DATE: February 5, 2026

ADDENDUM NO. 5

PROJECT NO. DGS C-0946-0012 PHASE 006
PROJECT TITLE - PA State Museum & PHMC Tower - Infrastructure Upgrades and Renovations
PROFESSIONAL:
Design Resources Group Architects AIA
270 Davidson Ave, Suite 303
Somerset, NJ, 08873

5 M120 MECHANICAL PLAN - TOWER LEVEL 15 - COLLECTIONS
1/8" = 1'-0"

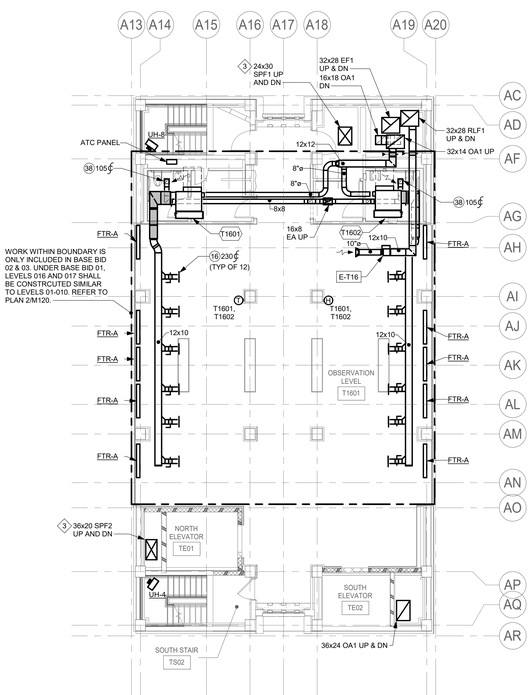
Item 20 - Regarding the HVAC tower ductwork shown on Drawing M120, both configurations are viable per 1M406 and 1M409, which demonstrate the arrangement of the humidifier manifold downstream of the duct elbow. This arrangement is reflected on all small-scale collections floor plans on M120. 1M408 and 2M409 show an alternative arrangement where the humidifier manifold is set upstream of the duct elbow. Either configuration is acceptable at the contractor's option. The minimal absorption distance, in a straight run between the humidifiers, manifolds and duct elbows must be maintained. Air devices shall be installed in all supply air dischargers per Drawing M120.

Item 33 - Drawing M120 - At Level 15 Plan, revised duct sizes to coordinate with 2/M409.

DRAWN BY	DATE	DRAWING NUMBER
KEH	10/10/2025	M200G.1
CHECKED BY	SCALE	
DC	1/8" = 1'-0"

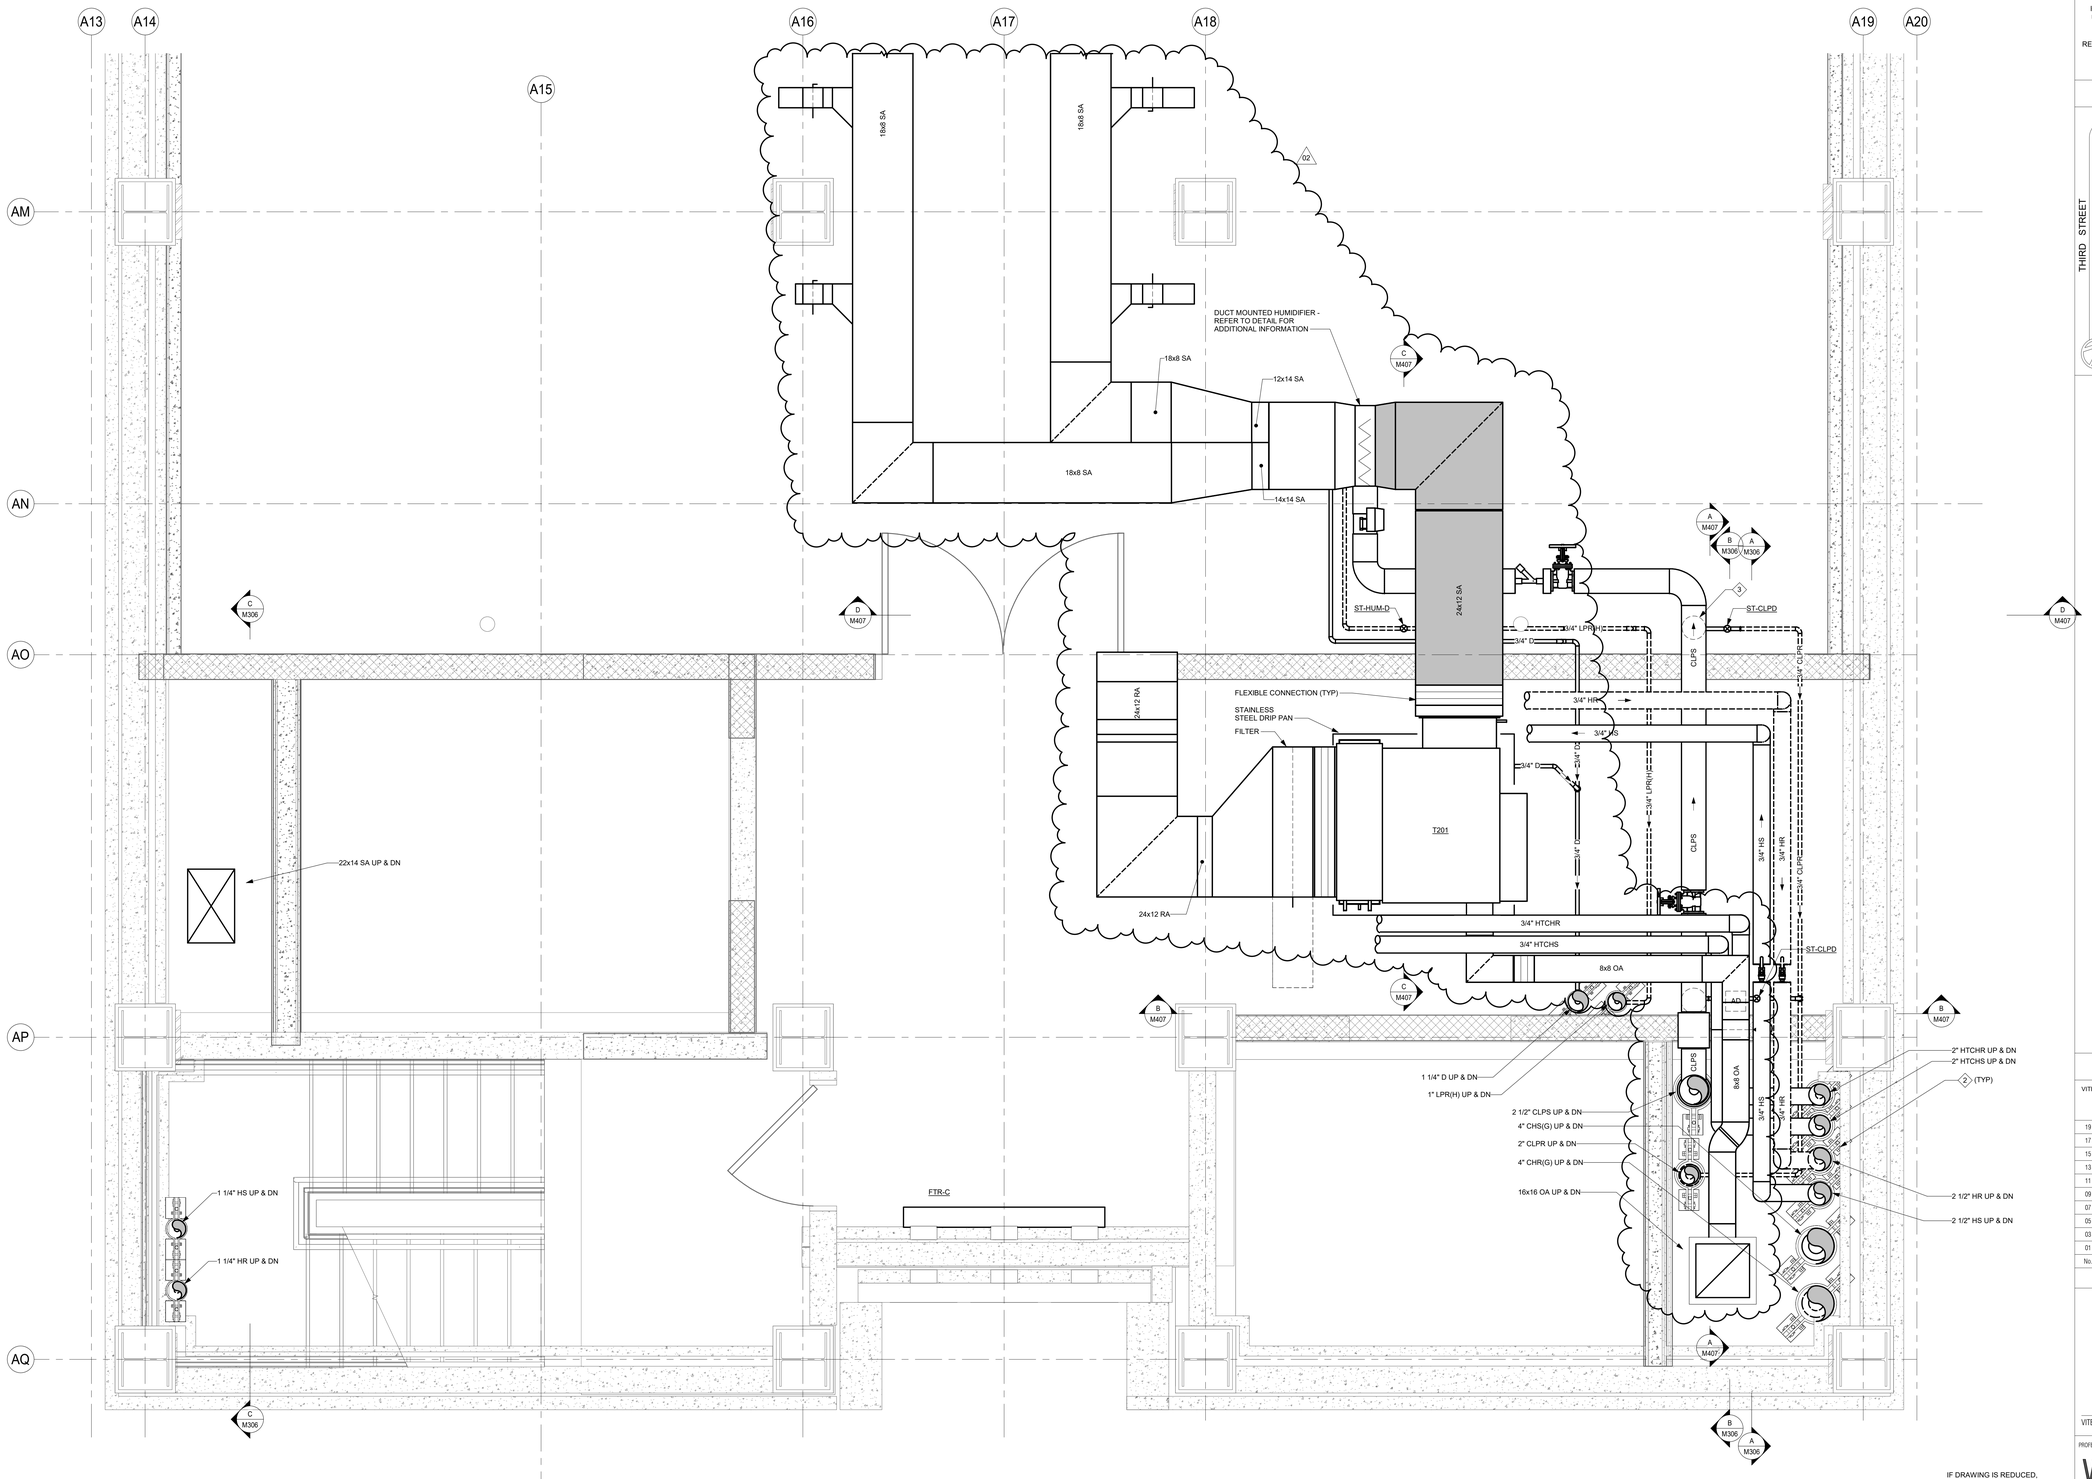
Item 34 - Drawing M200G.1 - Revised pipe sizes for hot and chilled water supply and return piping.

1 M408 ENLARGED PART PLAN - TOWER LEVEL 06 - VESTIBULE WITH IT ROOM ABOVE
3/4" = 1'-0"

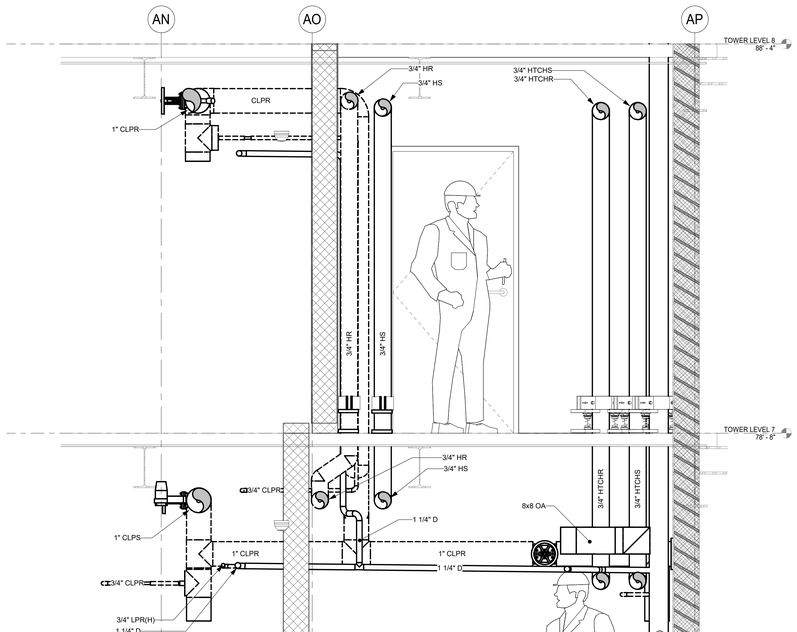
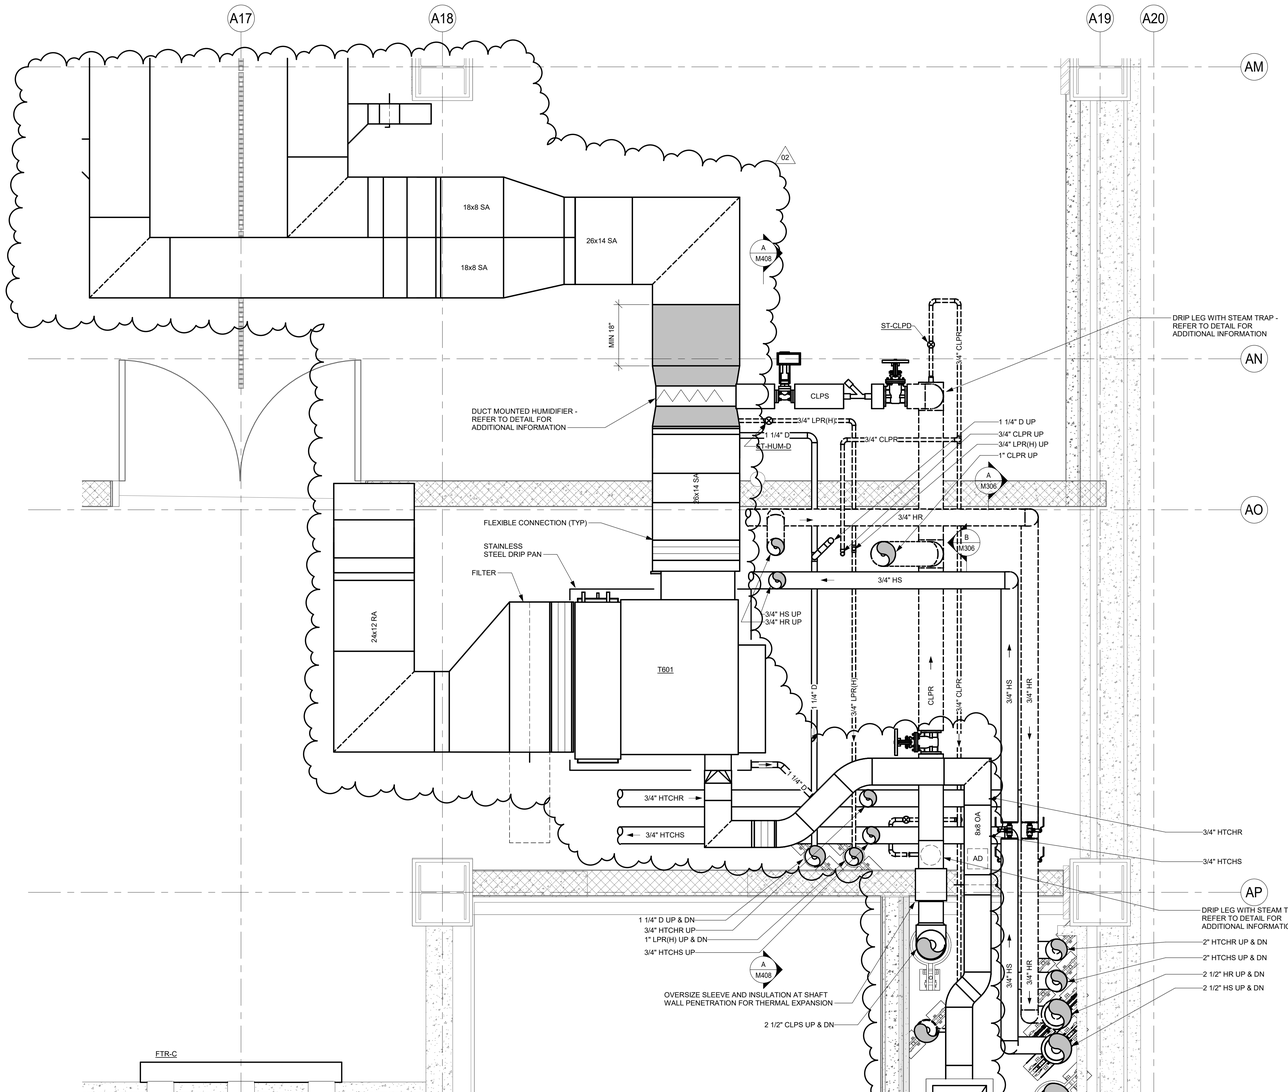
Item 36 - Drawing M408 - Clarified extent of internal duct lining.

1 M409 ENLARGED HVAC PIPING - TOWER LEVEL 14 - VESTIBULE WITH IT ROOM ABOVE

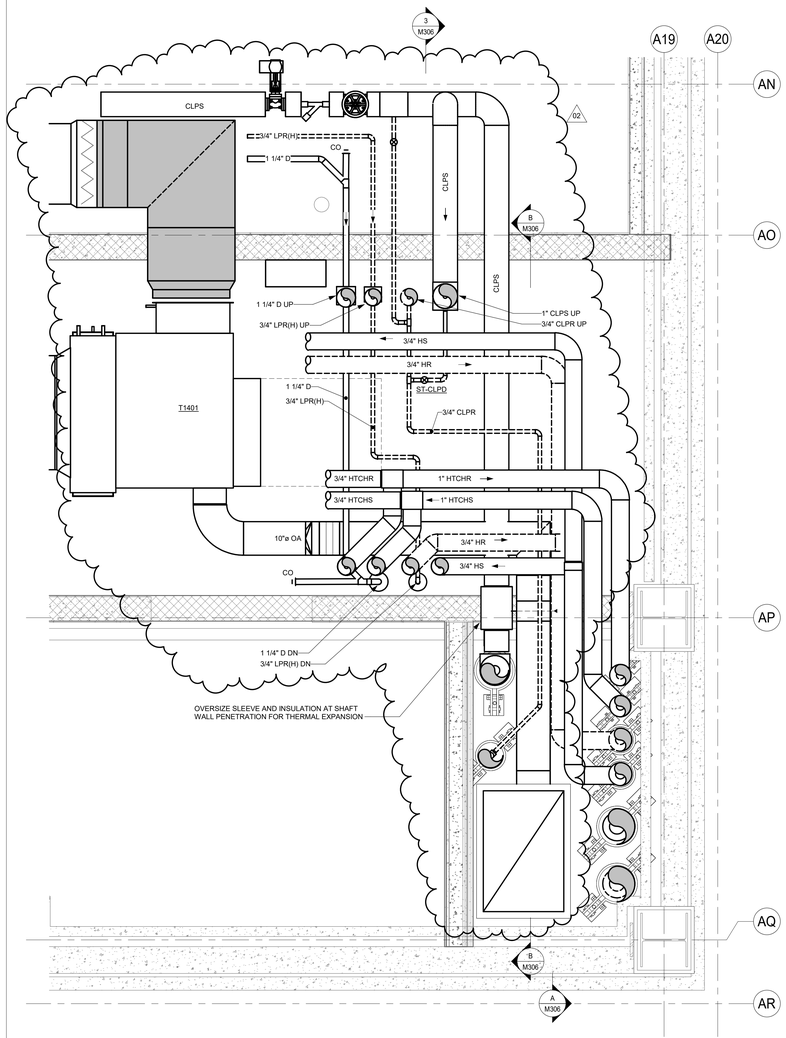
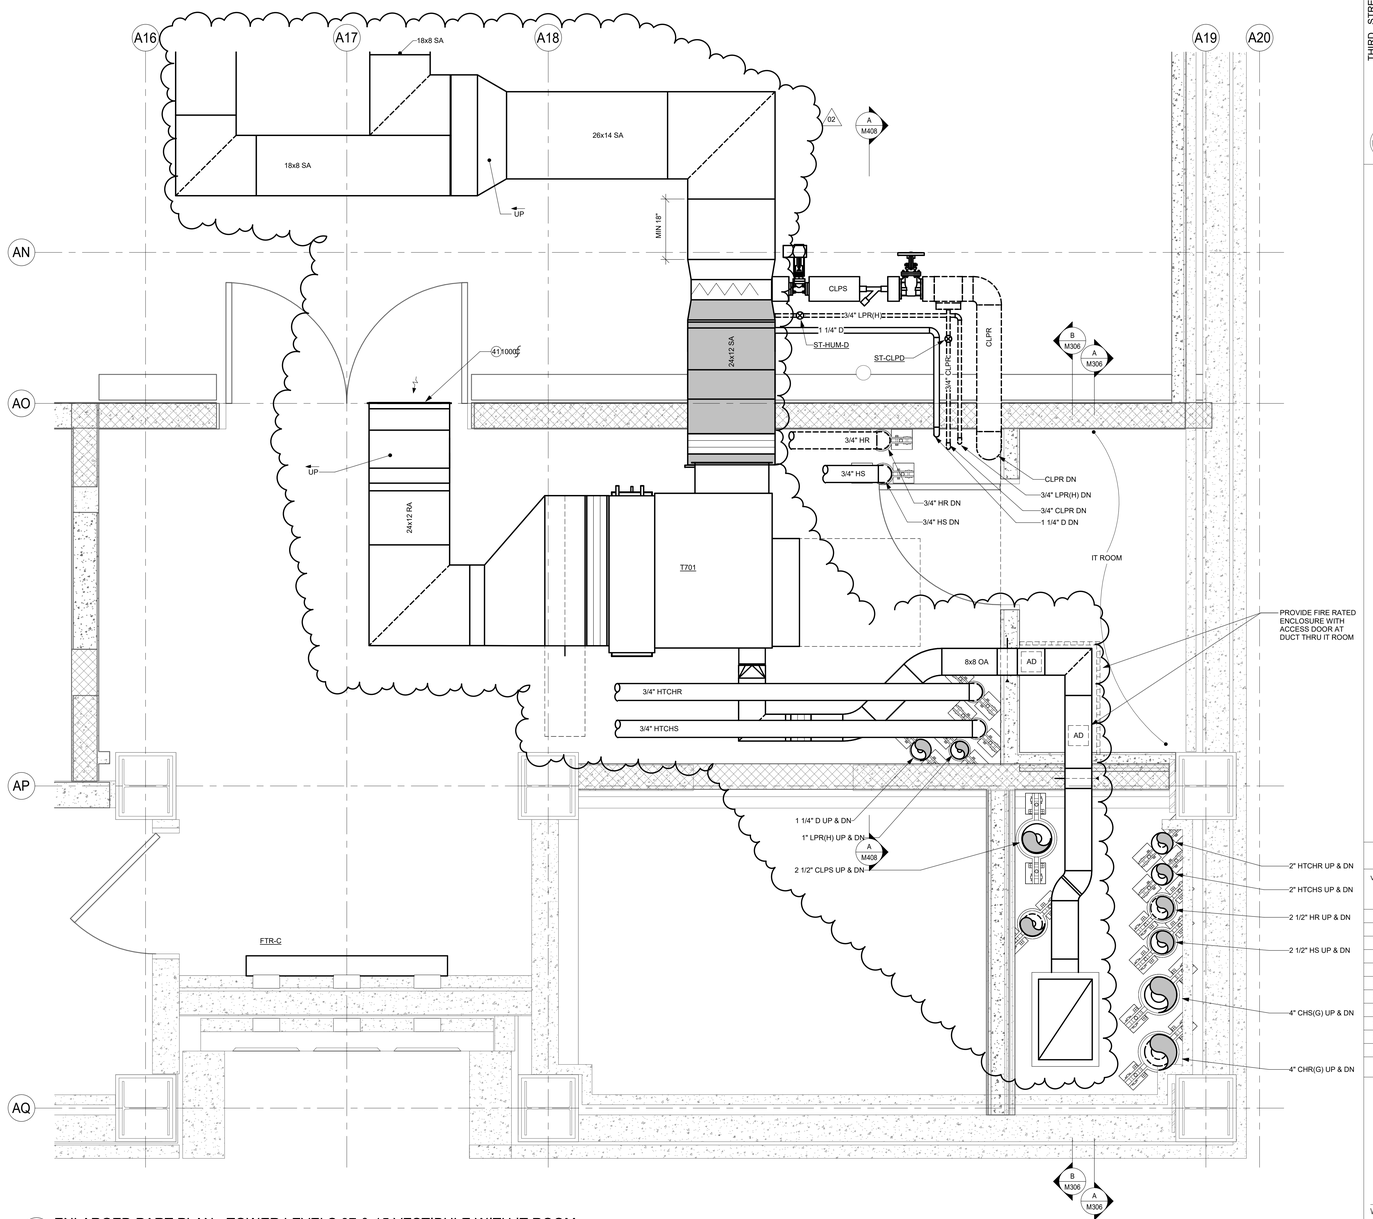
Item 37 - Drawing M409 - Clarified extent of internal duct lining.
